REMARKS

Applicants' attorney, Leslie Nguyen, would like to thank Examiner Burch for the courtesies extended during the telephonic interview conducted on April 19, 2006 regarding the drawing objections raised in the Office Action mailed March 3, 2006. An Interview Summary follows, after which the objections contained in the Office Action are addressed.

Amendments to the Drawings

FIG. 1b

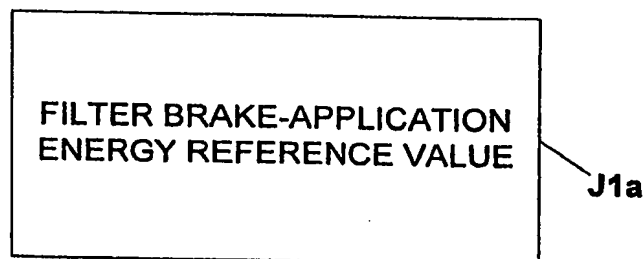
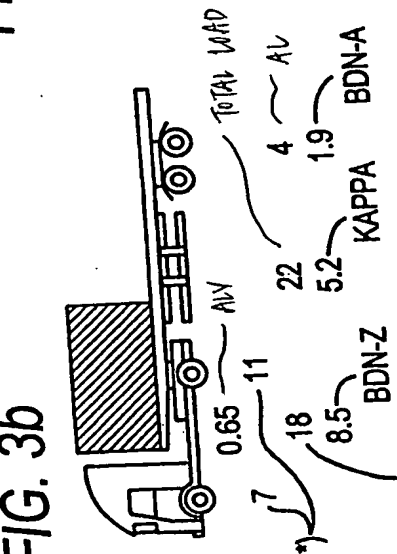
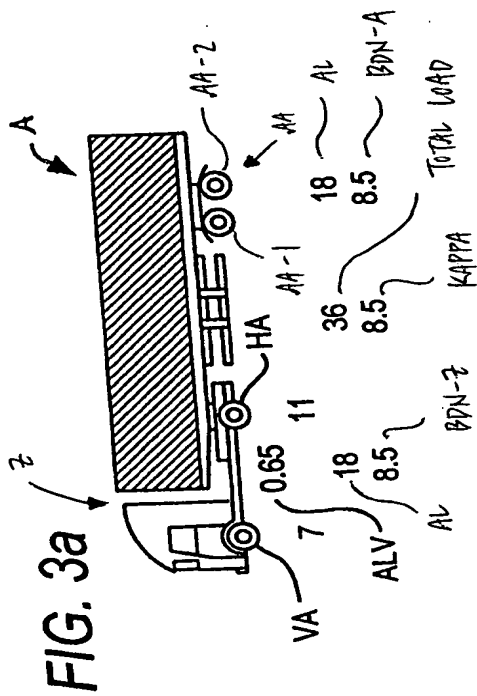
The Examiner objected to the drawing sheet containing Figs. 1b and 1c for containing the phrases “Annotated Marked-up Drawing Sheet” and “New Figure Added”. Applicants have submitted a Replacement Sheet containing Figs. 1b and 1c to replace the prior drawing sheet. This Replacement Sheet has been amended to delete the phrases “Annotated Marked-up Drawing Sheet” and “New Figure Added” and to include “New Sheet” as requested by the Examiner. It is submitted that this Replacement Sheet is in compliance with 37 CFR 1.121(d).

In addition, a Replacement Sheet containing Figs. 1b and 1c are submitted herewith. This Replacement Sheet replaces the phrases “Annotated Marked-up Drawing Sheet” and “New Figure Added” with “New Sheet” as suggested by the Examiner. No new matter has been introduced.

FIG. 4a

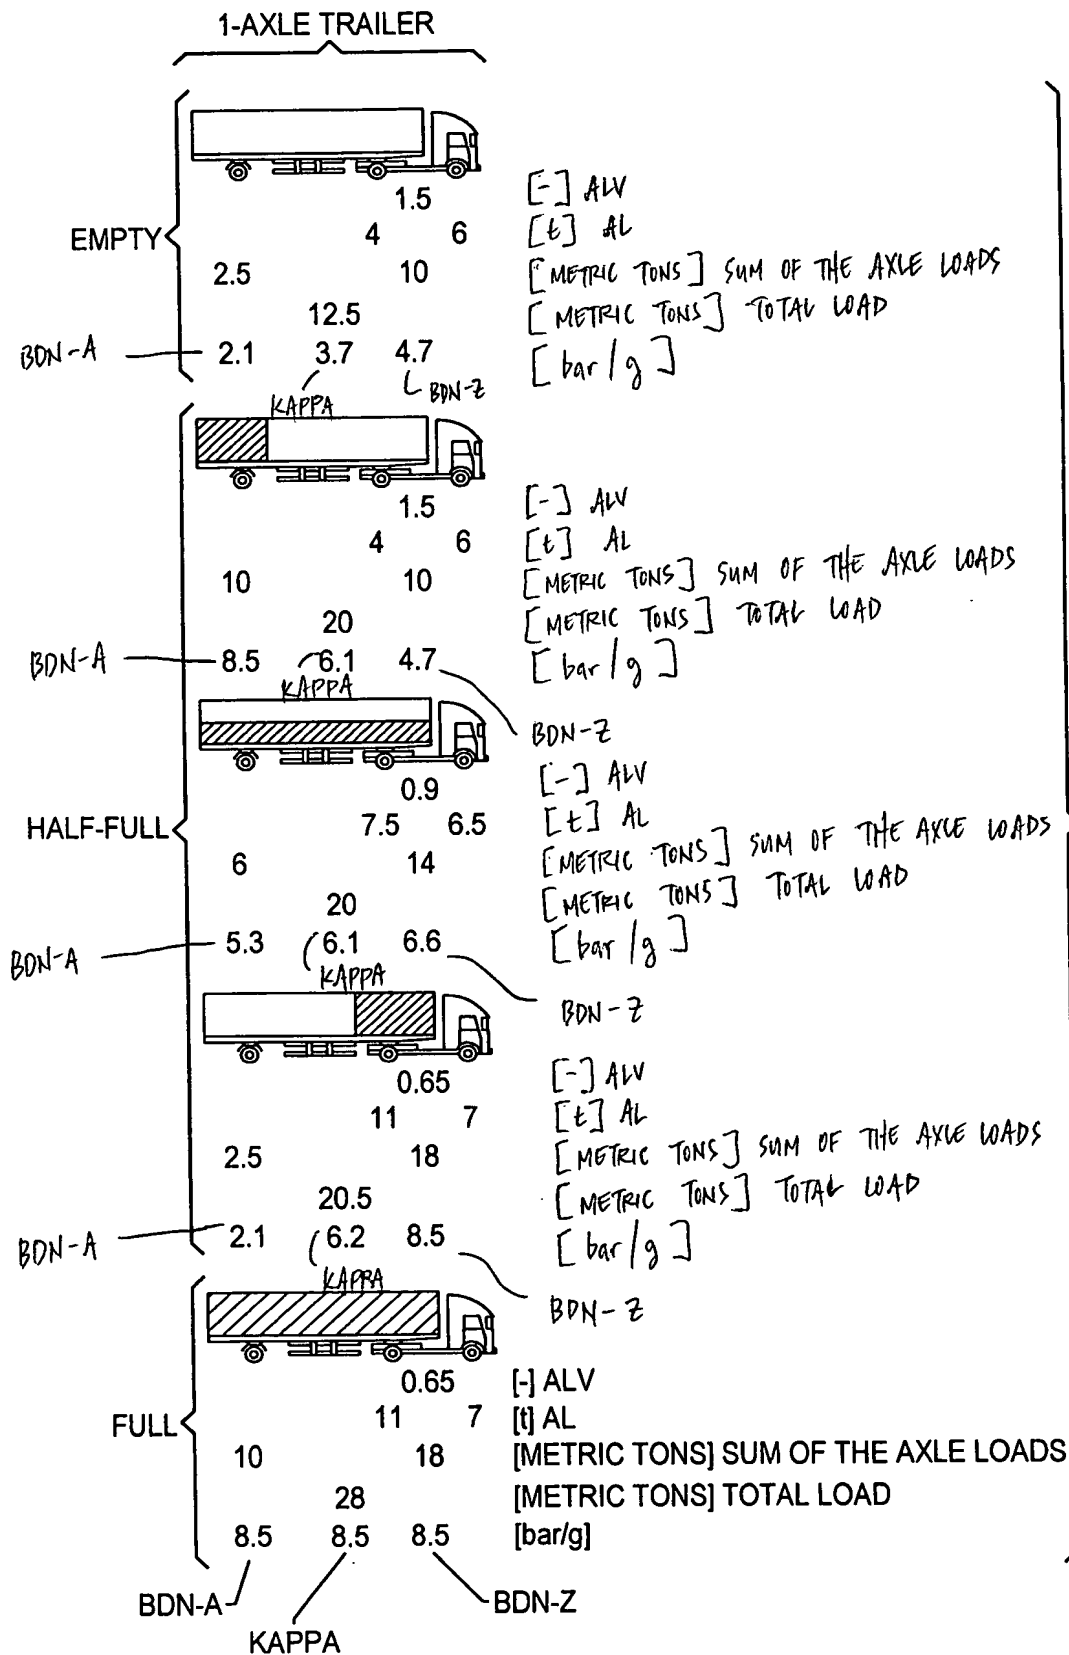
Regarding the Examiner’s objection to Figs. 3a-3e, 4a-4c, 5a-5i, 6a-6e, and 7a-7e, the Examiner suggested that each and every element in these respective figures required labeling even though Applicants’ attorney noted that each element could be understood based on the previous labeling of the figures.

Applicants have also amended Figs. 3a-3e, 4a-4c, 5a-5i, 6a-6e, and 7a-7e to label each and every element in these respective figure according to the suggestions made by the Examiner during the interview conducted on April 19, 2006. The elements of the respective figures are fully supported by the original application specification. Accordingly, no new matter has been introduced.

New Figs. 3a-3e, 4a-4c, 5a-5i, 6a-6e, and 7a-7e include additional element labels as suggested by the Examiner.

FIG. 9

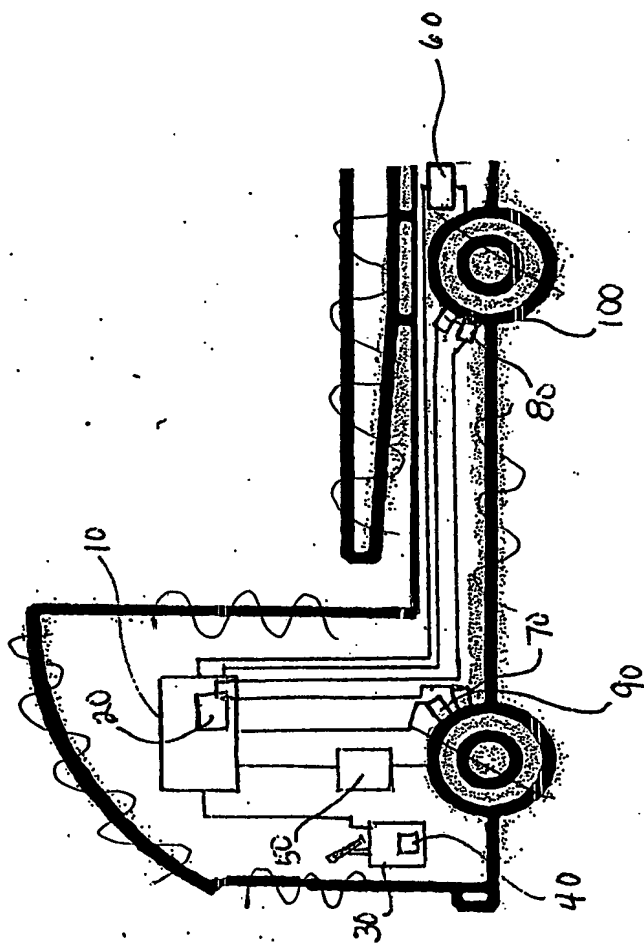
Regarding the Examiner's objection to the inclusion of Fig. 9 in the application, Applicants' attorney maintained that the elements depicted therein (*i.e.*, an EBS (including an EBS control unit 10), a means for determining actual deceleration 20, a brake pedal 30 (including a signal transmitter for desired brake values 40), brake actuators 50, 60, the wheel

The Examiner acknowledged that Fig. 9 was initially added at the Examiner’s request. The Examiner then suggested that Fig. 9 be amended to only include a “black box” diagram of the conventional EBS (i.e. removing the “picture of the truck” from Fig. 9).

In the Office Action, the Examiner stated that Fig. 9 should be deleted because it is not supported by the original disclosure. If Applicants were to delete Fig. 9, the Examiner required that the axle load sensors recited in claim 17 and the means for determining a set deceleration value, means for measuring actual deceleration and means for comparing the set and actual deceleration values as recited in claim 26 be shown in the drawing figures.

To address the Examiner's concerns and promote the application to early allowance, as depicted in the attached Replacement Sheets, Applicants have added new Fig. 9 to the drawings which, as suggested by the Examiner during the interview conducted on April 19, 2006, is a simplified "black box" diagram of a conventional tractor-trailer vehicle combination showing an EBS and including an EBS control unit 10 (which includes the capability of effecting filtering of the brake application energy reference value) and means for determining actual deceleration 20, a brake pedal 30, including a signal transmitter for desired brake values 40, brake actuators 50, 60 for the front and rear axles, respectively, wheel speed sensors 70, 80 and

axle load sensors 90, 100. Support for the addition of new Fig. 9 resides in at least claims 17 and 28. Accordingly, no new matter has been introduced.

New Fig. 9 is a simplified schematic diagram depicting a conventional EBS for a conventional tractor-trailer vehicle combination including an EBS control unit 10 and means for determining actual deceleration 20, a brake pedal 30, including a signal transmitter for desired brake values 40, brake actuators 50, 60 for the front and rear axles, respectively, wheel speed sensors 70, 80 and axle load sensors 90, 100. No new matter has been introduced.
